L-2000
ASAT BASS
L-2500

NEW WIRING

7/98

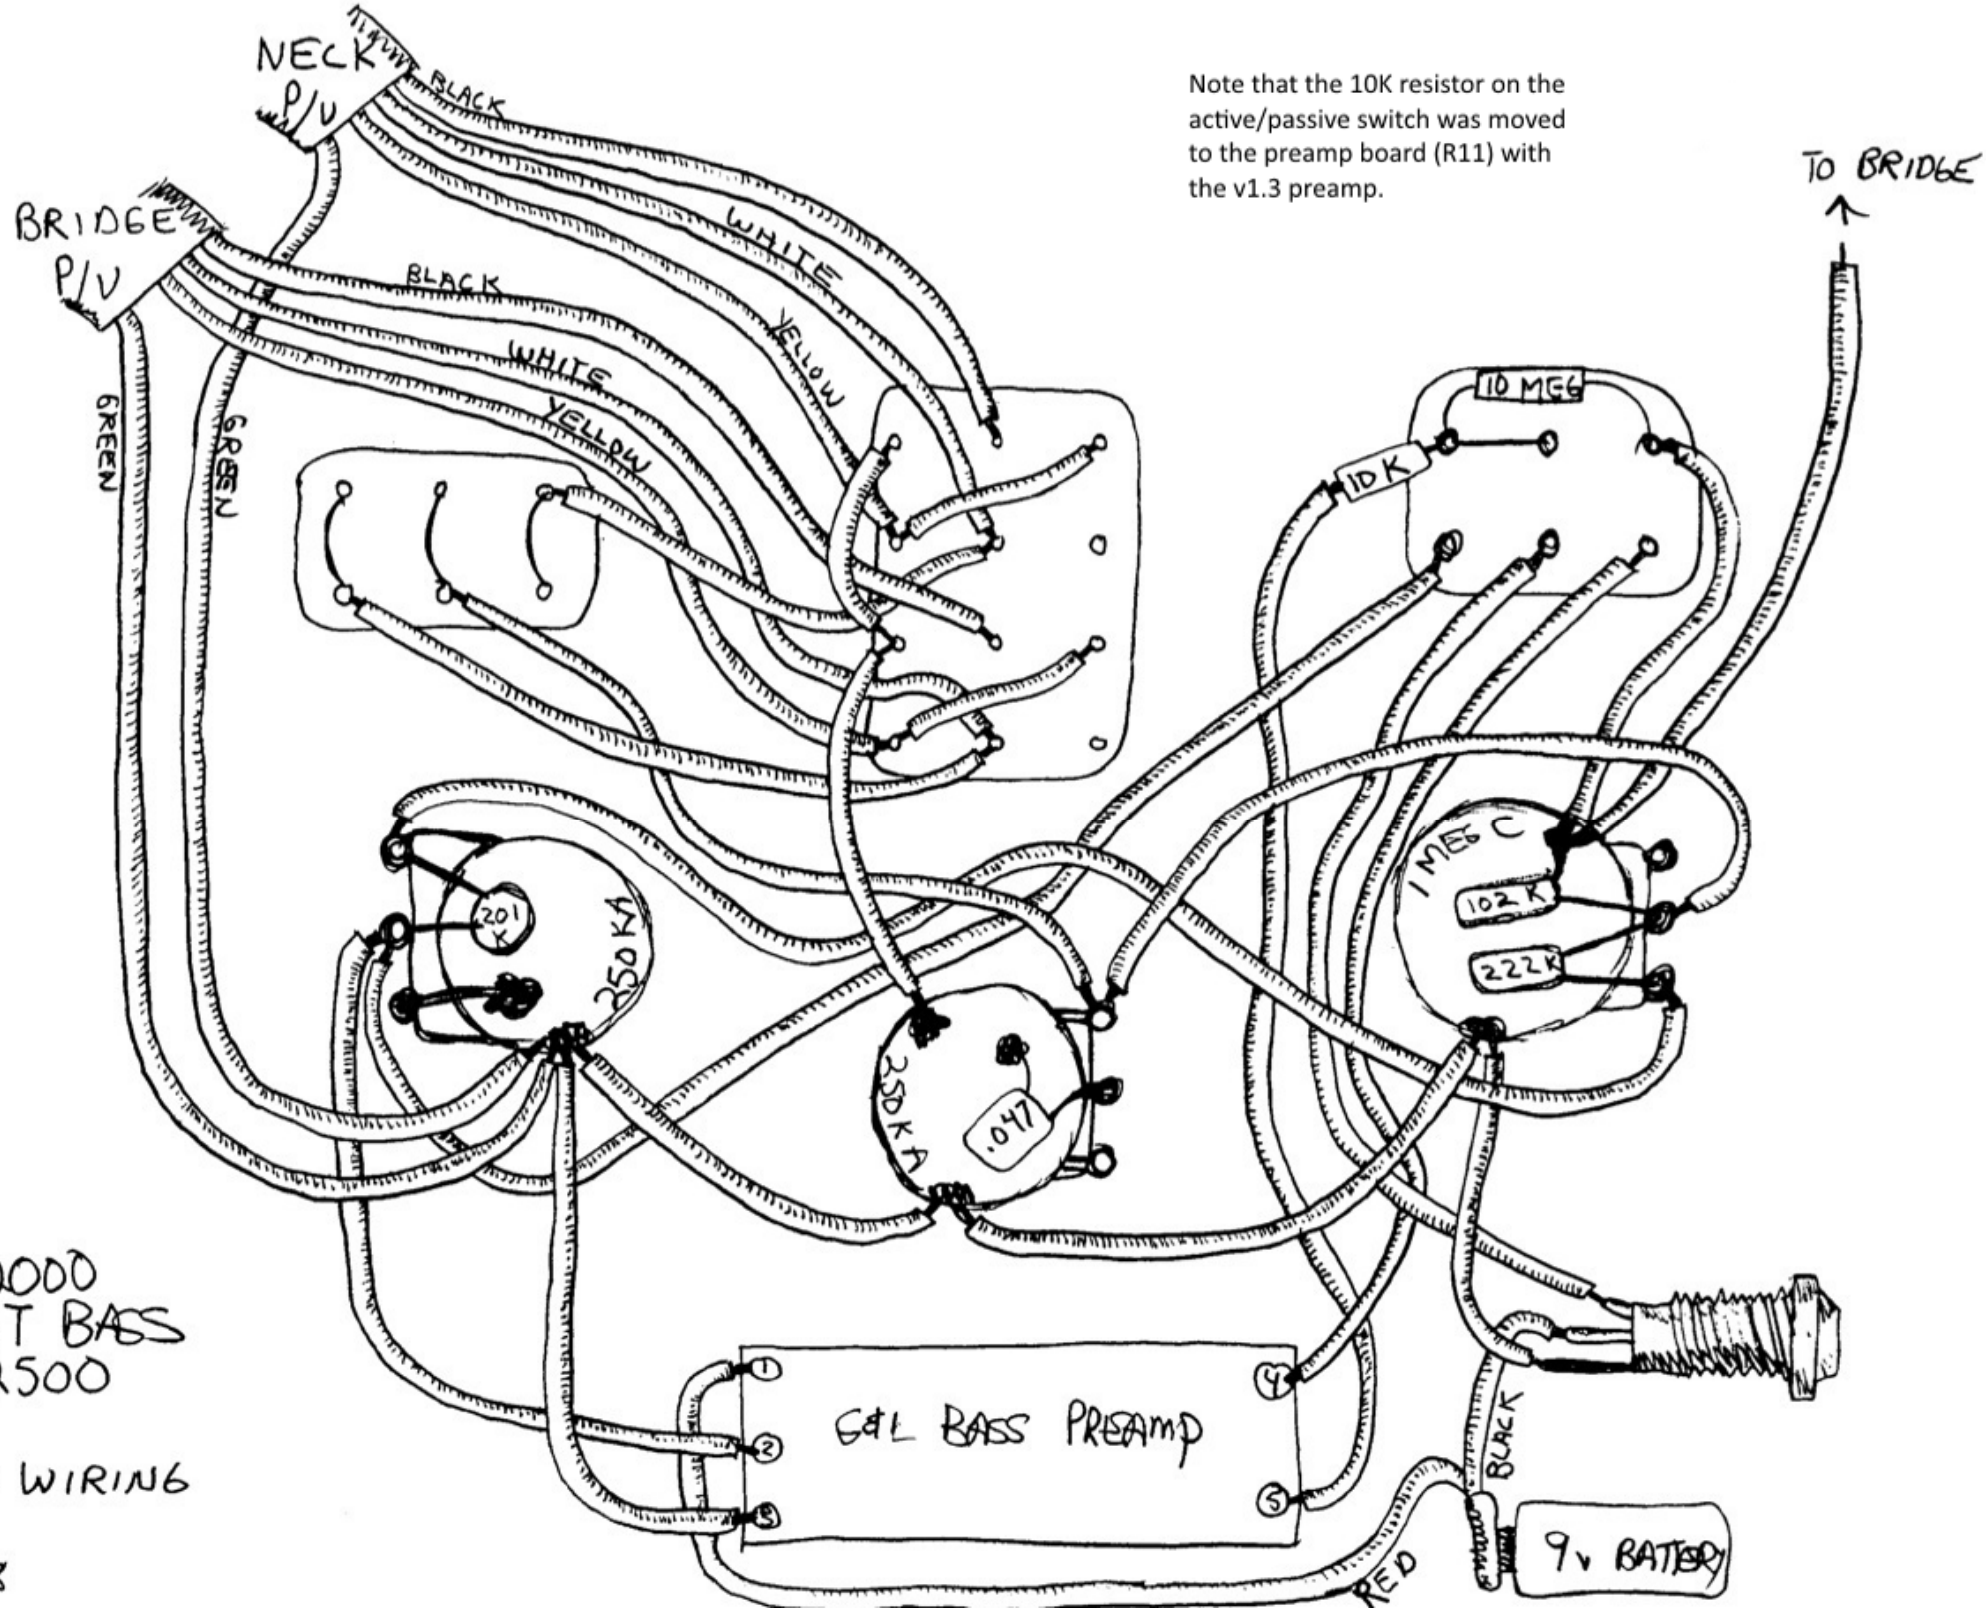
Note that the 10K resistor on the active/passive switch was moved to the preamp board (R11) with the v1.3 preamp.
